PLANNING DEPARTMENT REPORT

REPORT 16/42

SUBJECT: ZONING BY-LAW AMENDMENT 01/16 & Subdivision D12
23T-16001 – Charleston Homes – Bonarrow Meadows –
Public Meeting

LOCATION & WARD: 5155 Fourth Line – Ward 3

**DRAFT PLAN OF SUBDIVISION
BONARROW MEADOWS**

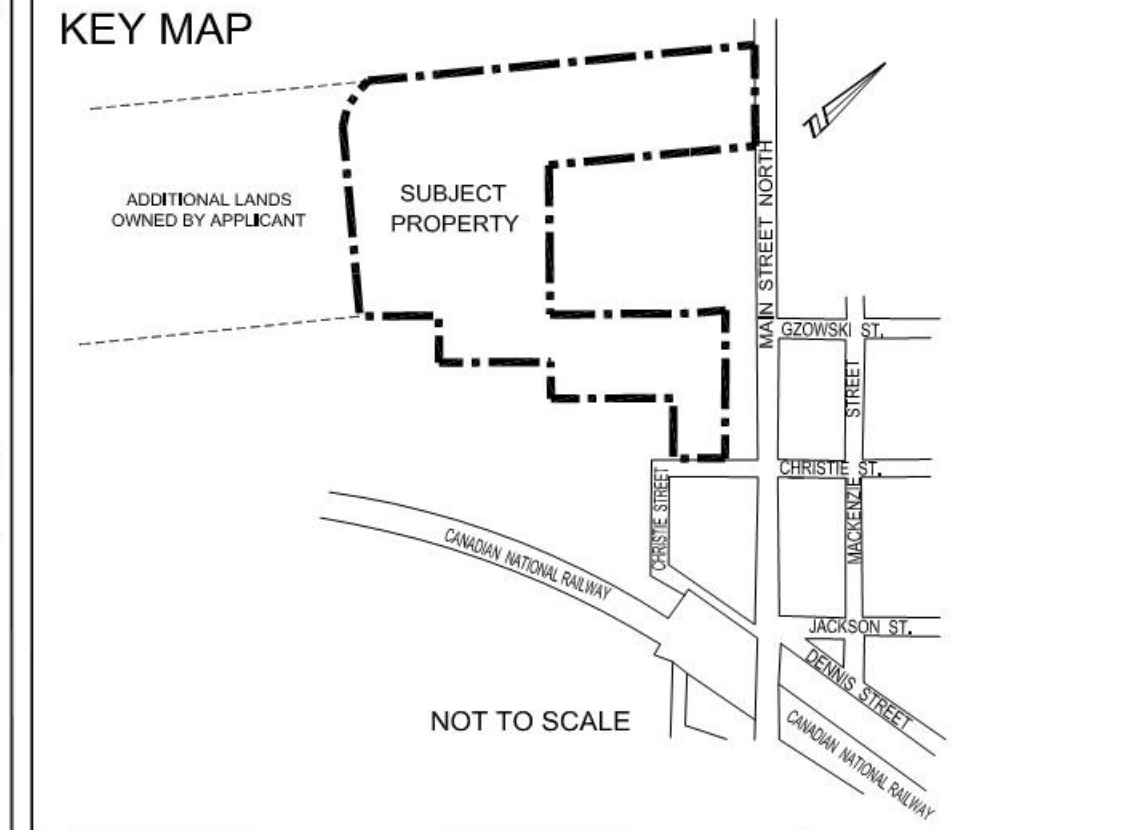
- Access to Block 172 SWM pond and its outlet will be required. Access can either be gained through conveying Lot 99 to the Township or by re-evaluating the easement length and width shown on the west of the development. This easement could be extended (grading permitting) to the boundary with Rockmosa Park where access can be gained to the SWM block and outlet.

- In the pre-consultation meeting it was requested to have the 20 m ROW of Street E extend north to the intersection of Street B. Please review. It should also be noted that a new typical 18 m ROW detail will need to be established since the Township currently does not have one. Particular attention will need to be made to tree placement in relation to services.

- Need to extend linkages on County Road 27 between the school driveway and Street A.
- Lots 56 and 57 are located very close to County Road 27. These lots should be re-evaluated with respect to distance to County Road 27, driveway location, queuing and noise.

- The northeast portion of the property (behind lots 57-61) should not be filled or altered as this may negatively affect the lot to the north. Planting plans should consider the tile running through this area.

- We have reviewed the size (15 m x 25 m) of the Block 173 for the sewage pumping station (SPS) and find it smaller than typical. Please review and comment. Illustrating how all works can be accommodated on site would be beneficial.

- The southerly walkway connection does not seem to reflect the previously identified location. It appears from this draft plan that the connection is directly in line with the existing garbage enclosures. We are asking the Township to review this location to ensure that the walkway connection does not create a need for the School Board to revisit any grading of their site and/or relocation of the garbage enclosure.

- As per the Burnside comments, access to the outlet control structure in SWM Block 172 is required. Similarly access will be required to the piped portion of the outlet located in the 5 m easement behind lots 99 to 105. Access to the open channel portion of the drainage easement between the development land and existing farm pond is also required.

- The final detail for an 18 m cross section should be approved prior to draft plan approval. Based on a preliminary review of 18 m sections from other jurisdictions something can be developed to work here. However an 18 m cross section will NOT be permitted where sidewalk is required on both sides of the street. Accordingly, the sidewalk layout does need to be shown at this time.

- Review of the preliminary grading drawing indicates that the average slope on the rear yard swale from lot 37 to the Block 168 is approximately 1% and is over 150 metres in length. As proposed, the swale length and slope do not meet minimum lot grading design criteria and is not acceptable. Grading coordination with the adjacent property to the south is recommended. Shifting the drainage easement to the Lot 47/48 lot line which appears to the existing low point on the property line will also reduce the swale length and increase the minimum slope with less reliance on grading coordination.

- As discussed during the recent meeting with the applicant, the five metre drainage easement is behind lots 14 to 23 and the drainage easement along lot 22 are to be eliminated as there is sufficient grade from the rear property line for sufficient back to front drainage. The grading design of the adjacent school site was coordinated with the subdivision and fill slopes were extended in to the subdivision to avoid rear yard swales.

- We have concerns over the proposed minimum side yard setbacks for Townhouse dwellings. Block 166 proposes 16 units in no less than 3 separate buildings based on two drainage easements within the block. The

minimum interior side yard proposed for townhouses under Section 9.2.6.5 in the planning report is only 1.5 with 3 m between foundations of separate buildings. The foundation edge should not be immediately adjacent to the edge of any easement.

- The drainage easements shown on lot lines appear to straddle the lot line with part of the easement on each lot. The development standards require that easements be located on one side of a common lot line. Where drainage easements are required along lot lines they are therefore to be contained entirely on one lot.

- As discussed during the meeting with the applicant, the rear yard easements on lots 118 to 128 and 140 to 150 should be eliminated by grading the lots with back to front drainage. Lots 123 and 124 are 11 m frontage in the group from 118 to 128 while lots 142 to 148 are 11 m frontage in the 140 to 150 group. The planning report is proposing interior side yard setbacks of 1.2 m on side and 0.6 m the other for a minimum 1.8 m between foundations. As a result back to front drainage does present some grading challenges. Public works is of the opinion that the minimum setback should be reviewed further. Increased setbacks also allow for improved rear yard access where air conditioners and gas regulators, hydro meters are typically installed in the side yard area further reducing access.
